NETWORK UPDATE FORM

NM Area	<u>Rotorua DC</u>	NM Consultant	<u>Opus Rotorua</u>
Project Name	<u>Miki Bridge RS redefinition</u>		
Effective Date	<u>1 / 1 / 2005</u>	PROMAN Number	<u> </u>
Prepared by	<u>Royce Green</u>		
Phone Number	<u>07 862 7732</u>	Prepared Date	<u>10 / 1 / 2005</u>

Sketch of Network Change (include side roads and their location and attach additional information if required)

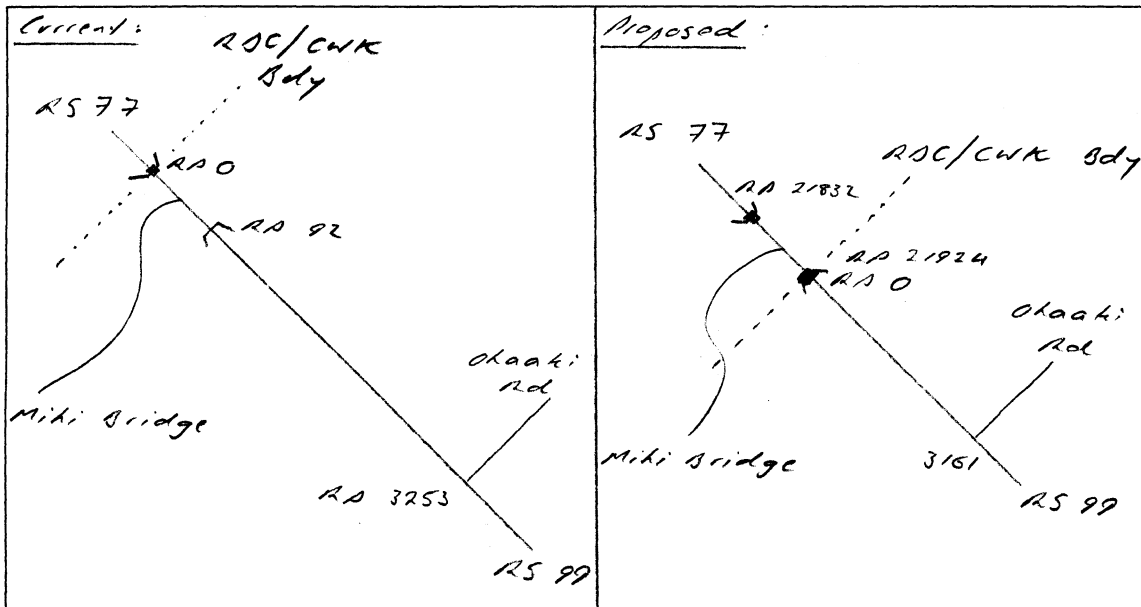
RS <input type="checkbox"/> New <input type="checkbox"/> Revoked <input checked="" type="checkbox"/> Move <input type="checkbox"/> Length Change
DIVIDED CARRIAGEWAY <input type="checkbox"/> New <input type="checkbox"/> Extend / shorten | ROUNDABOUT <input type="checkbox"/> New <input type="checkbox"/> Remove
INTERCHANGE <input type="checkbox"/> New <input type="checkbox"/> Renumber
RAMP <input type="checkbox"/> New <input type="checkbox"/> Merge <input type="checkbox"/> Remove |

Project Extent		Current		Proposed	
		Start (m)	End (m)	Start (m)	End (m)
State Highway	Reference Station	Start (m)	End (m)	Start (m)	End (m)
<u>005</u>	<u>0077</u>	<u>17449</u>	<u>21832</u>	<u>17449</u>	<u>21832</u>
<u>005</u>	<u>0077</u>	<u>—</u>	<u>—</u>	<u>21832</u>	<u>21924</u>
<u>005</u>	<u>0099</u>	<u>0</u>	<u>3253</u>	<u>0</u>	<u>3161</u>
